SUBJECT: ADDENDUM No. 1

FILE: FHWTP Flocculation and Sedimentation Basins 1 & 8 Equipment Upgrade WT7093

**FLEMING HILL WATER TREATMENT PLANT FLOCCULATION AND
 SEDIMENTATION BASINS 1 & 8 EQUIPMENT UPGRADE PROJECT – WT7093**

Z
TYP DETAILS OF STAGE-1
PEDESTAL BEARING ALIGNMENT

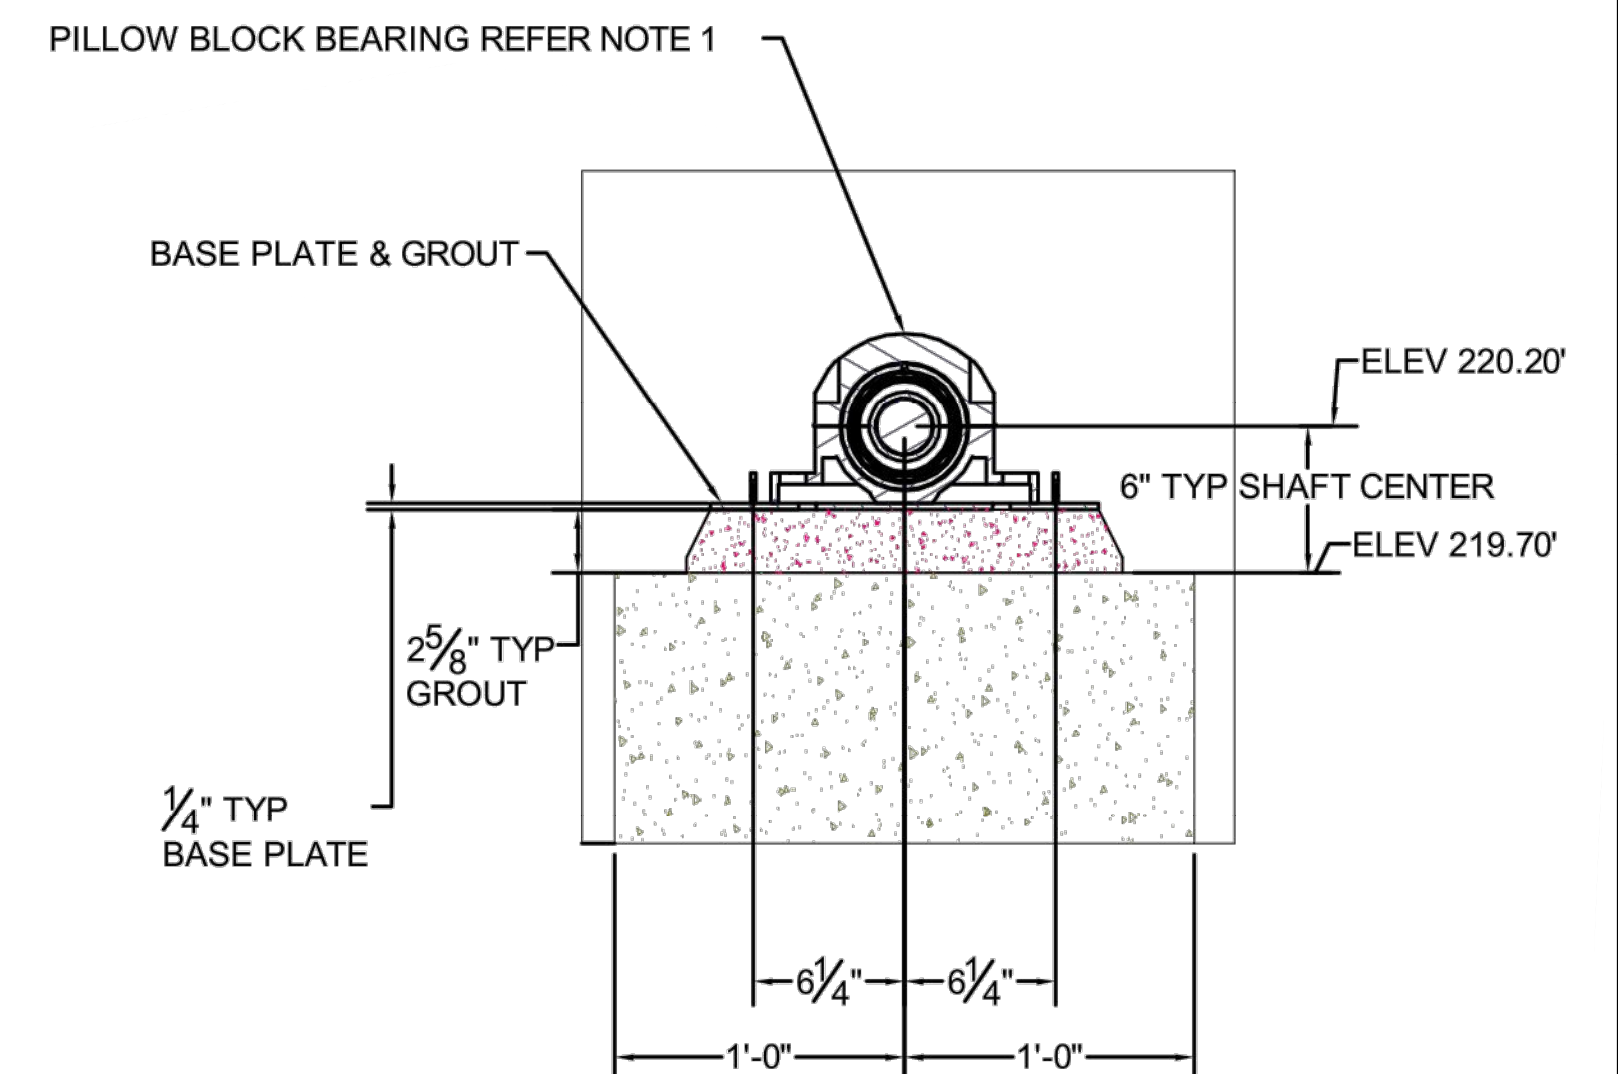
Sheet 7: Revised Notes. Moved Chain and Flight Details from Sheet 5.

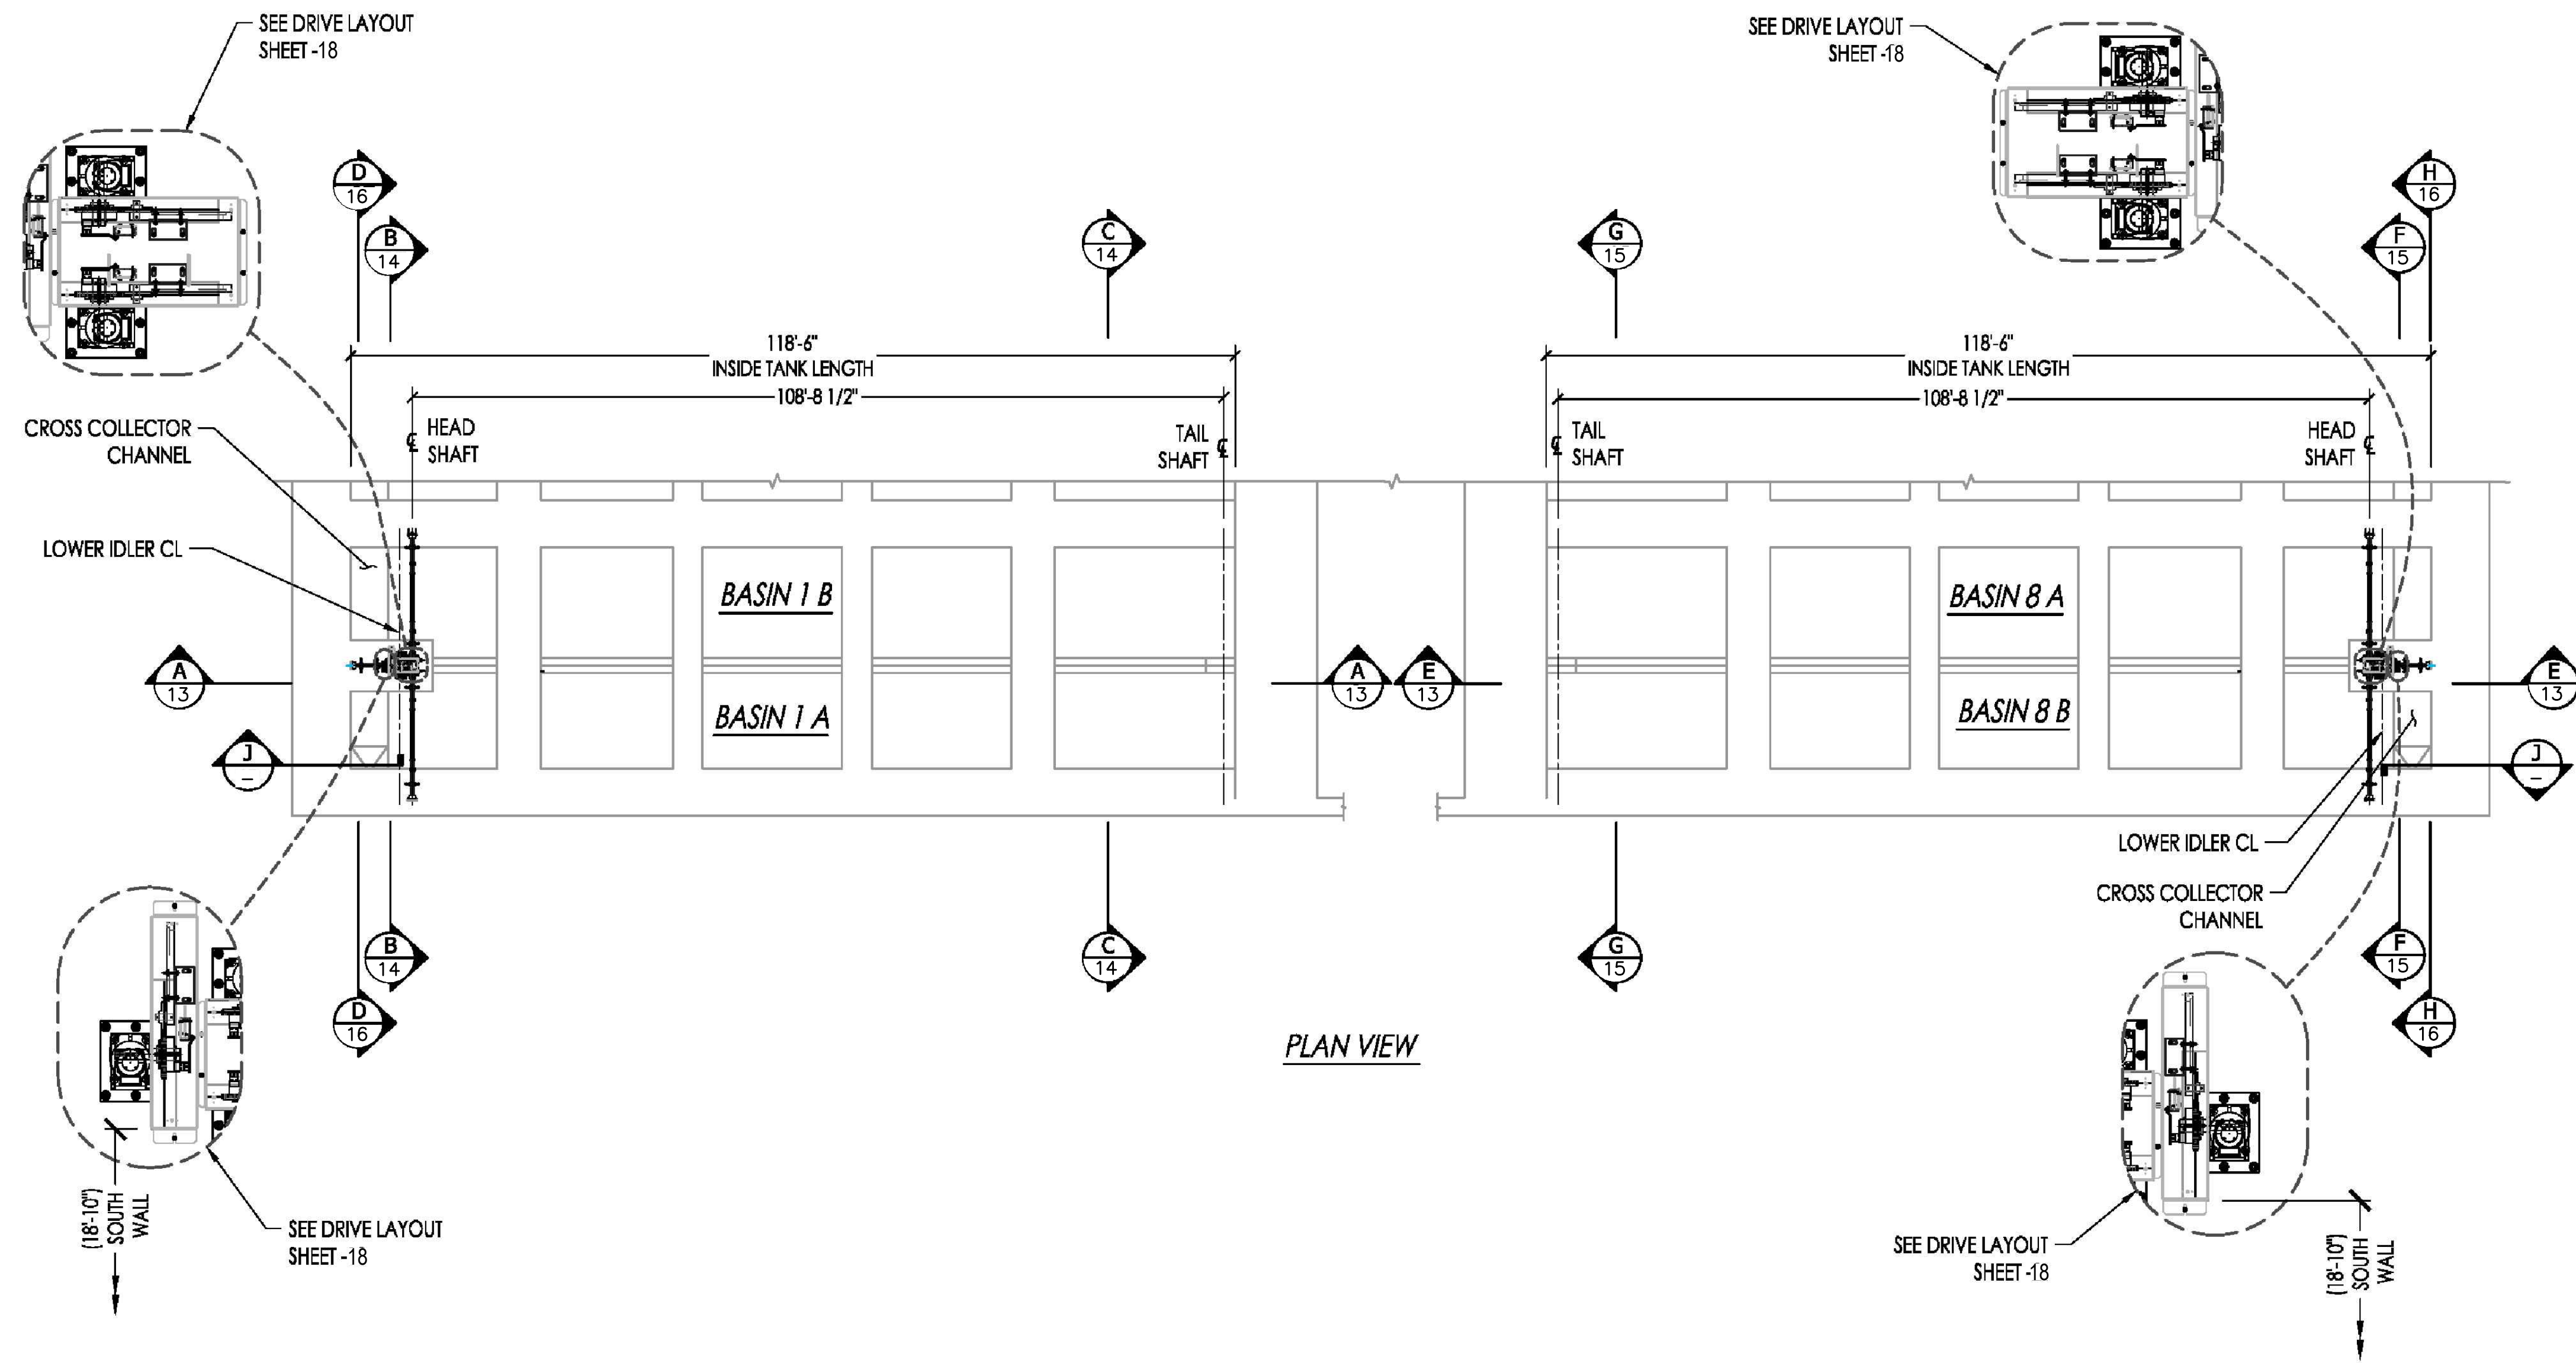
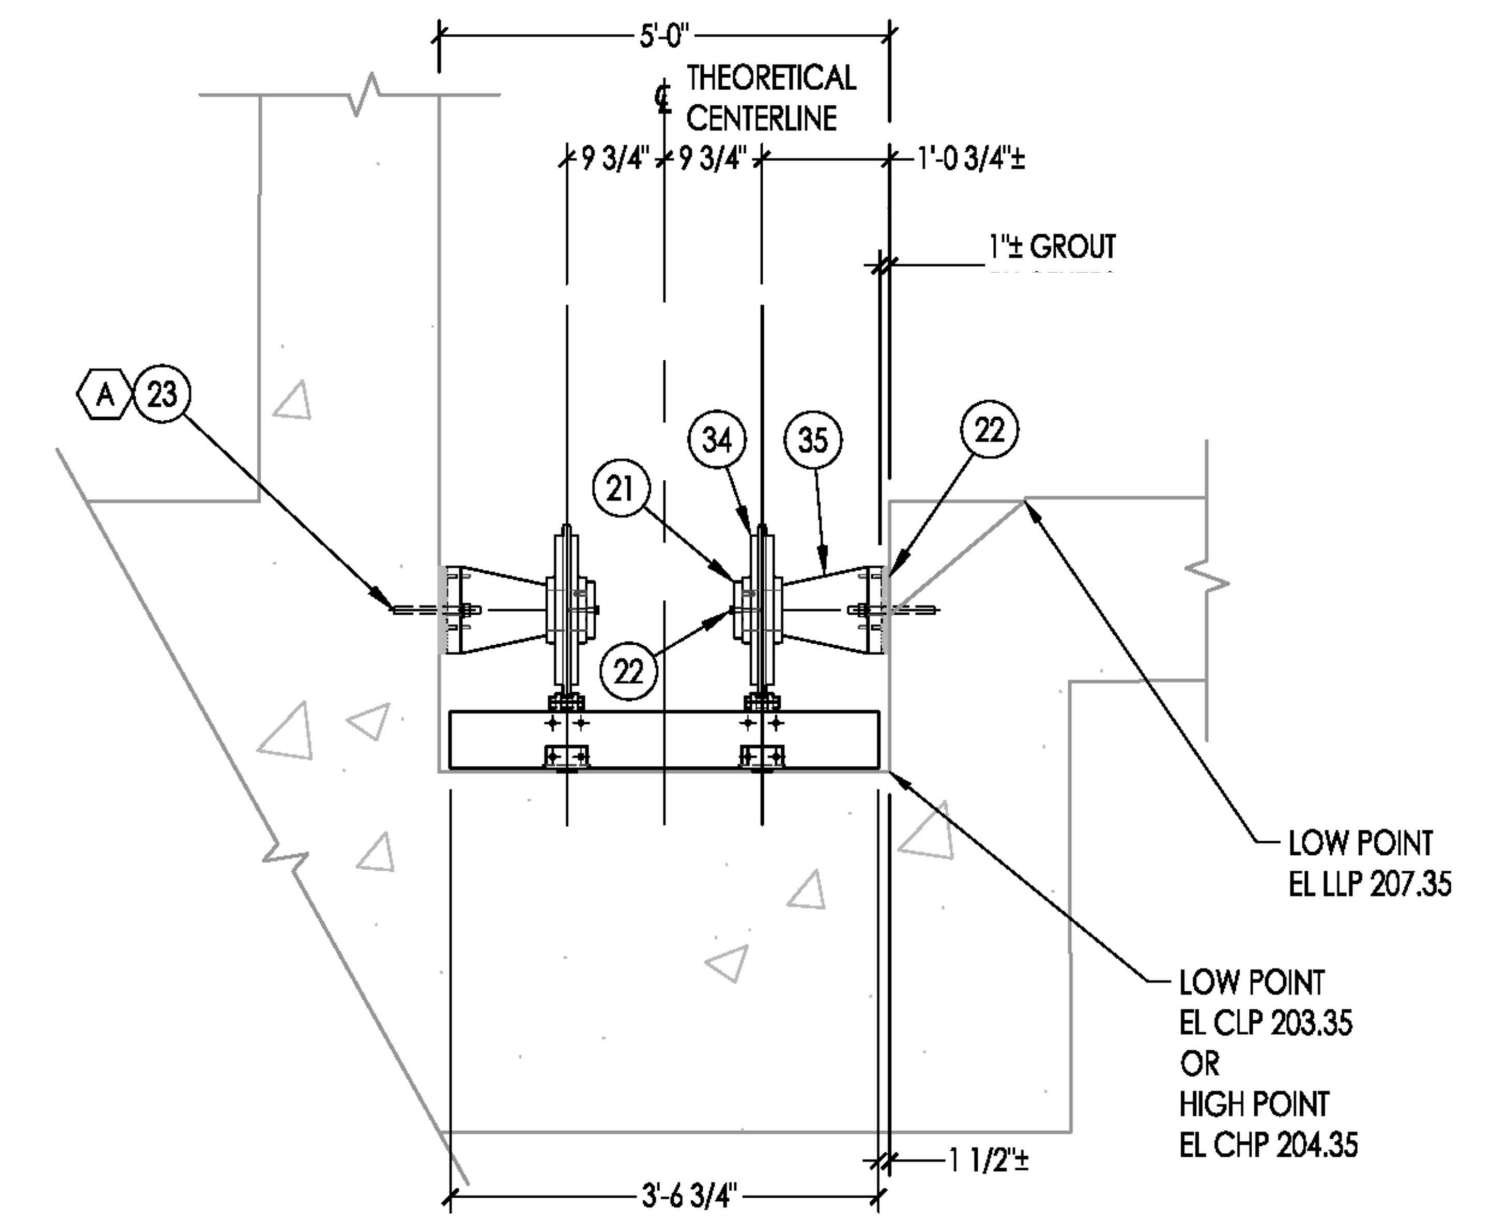
Sheet 8. Changed Plan View Description. Corrected Basin 1 Stage 3 View.
